Access Compliance Report

Public Rights-of-Way

(Curb Ramps)

Intersection ID: 45491	Main Street: GRASSY_CROPS_RD	Cross Street: TRIANGLE_PARK_RD	Location: SE
ADA ID: BAE2E62171B2	Ramp Type: PerpDiag	Initial Pass/Fail: Fail	Overall Compliance: No
Severity Score: 12.5			
Codes/Mitigation Info/Possible Solution		Field Measurements/Component Compliance

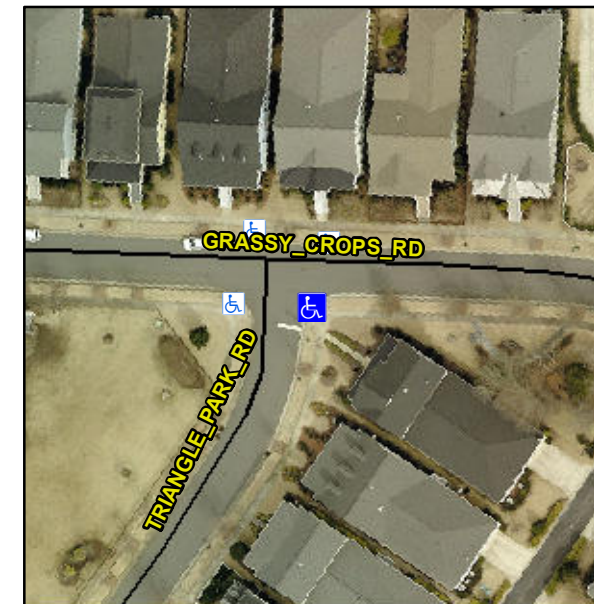
Not Found, R304.2.2

Compliance	Description	Data	Compliance	Description	Data
N/A	Ramp Length (in)	72.0	No	Ramp Slope (%)	8.9
Yes	Ramp Width (in)	48.0	Yes	Ramp XSlope (%)	0.6
N/A	Flare Type LT	N/A	N/A	Flare Type RT	N/A
N/A	Flare Slope LT (%)	N/A	N/A	Flare Slope RT (%)	N/A
N/A	Flare Traversable LT?	N/A	N/A	Flare Traversable RT?	N/A
N/A	Landing Length (in)	N/A	N/A	DWS Provided?	N/A
N/A	Landing Width (in)	N/A	N/A	DWS Contrast?	N/A
N/A	Landing Slope (%)	N/A	N/A	DWS Length (in)	N/A
N/A	Landing X Slope (%)	N/A	N/A	DWS Full Width?	N/A
N/A	Landing Curb? (Y/N)	N/A	N/A	DWS Offset (in)	N/A
N/A	Shared Landing?	N/A			
N/A	Gutter Ponding?	N/A	N/A	Gutter Slope (%)	N/A
N/A	Gutter Lip Ht (in)	N/A	N/A	Gutter X Slope (%)	N/A
N/A	Painted X Walk1?	No	N/A	Painted X Walk2?	No
	X Walk 1 Direction	To N		X Walk 2 Direction	To W
N/A	X Walk 1 Width (in)	N/A	N/A	X Walk 2 Width (in)	N/A
	X Walk 1 Slope (%)	2.2		X Walk 2 Slope (%)	1.2
	X Walk 1 X Slope (%)	1.2		X Walk 2 X Slope (%)	1.4

Remove & Replace Curb Ramp With Two New Directional Ramps or Equivalent.
